Project	IEEE 802.16 Broadband Wireless Access Working Group < http://ieee802.org/16 >	
Title	R-MAC Header Format Enabling Source QoS Control	
Date Submitted	2007-07-15	
Source(s)	Hang Zhang, Peiying Zhu, Mo-Han Fong, Wen Tong, David Steer, Gamini Senarath, G.Q. Wang, Derek Yu, Israfil Bahceci, Robert Sun and Mark Naden Nortel 3500 Carling Avenue Ottawa, Ontario K2H 8E9	Voice: +613-763-1315 E-mail: wentong@nortel.com Voice: +613-765-8983 E-mail: pyzhu@nortel.com
Re:	IEEE 802.16j-07/019: "Call for Technical Comments Regarding IEEE Project 802.16j"	
Abstract	In this contribution, R-MAC PDU format enabling source QoS control is proposed	
Purpose	To incorporate the proposed text into the P802.16j Baseline Document (IEEE 802.16j-06/026r4)	
Notice	<i>This document does not represent the agreed views of the IEEE 802.16 Working Group or any of its subgroups. It represents only the views of the participants listed in the "Source(s)" field above. It is offered as a basis for discussion. It is not binding on the contributor(s), who reserve(s) the right to add, amend or withdraw material contained herein.</i>

R-MAC Header Format Enabling Source QoS Control

Figure 1. Source QoS header.

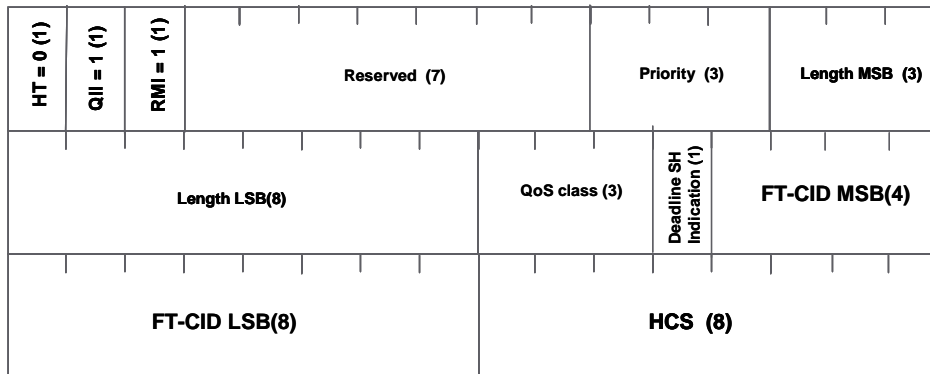
In contribution C80216j_07/424, source QoS control is proposed. For enabling source QoS control, the R-MAC header shall carry scheduling instruction: transmission deadline and QoS class. The format of source QoS R-MAC header is proposed in the following figure.

In this source QoS control R-MAC header, QoS class ID (3 bits) is included. Similar to 802.1Q-rev-d4, the 3-bit QoS class specifies the traffic type of 802.16 scheduling services and their priority: UGS (5), rtPS (4), ertPS (3), nrtPS (2) and BE (1). The deadline information may appear as a type of R-MAC sub-header. The presence of deadline sub-header is indicated by the Deadline SH indication bit.

In DL data forwarding using source QoS control method, the MR-BS R-MAC layer creates an R-MAC PDU with the header including scheduling instruction. The 12-bit FT-CID (Forwarding Tunnel CID) field is the reduced FT-CID of the destination RS.

In UL data forwarding using source QoS control method, an access RS R-MAC layer in R-link creates an R-MAC PDU with the header including the scheduling instruction. The FT-CID is the reduced FT-CID of this access RS.

The R-MAC header is used always with payload and can be used in both DL and UL. The source QoS R-MAC header shall carry scheduling instruction: QoS class and Deadline SH indication. When QII is set to 1, it indicates QoS class index and deadline indication are included in the R-MAC header, and the reduced 12-bit forwarding tunnel CID is used. The 3-bit QoS class specifies the traffic type of 802.16 scheduling services and their priority: UGS (5), rtPS (4), ertPS (3), nrtPS (2) and BE (1). The deadline sub-header will present if the bit of Deadline indication is set to 1. The format of source QoS R-MAC header is shown in Figure XXX.

Figure xxx. Format of source QoS R-MAC header.
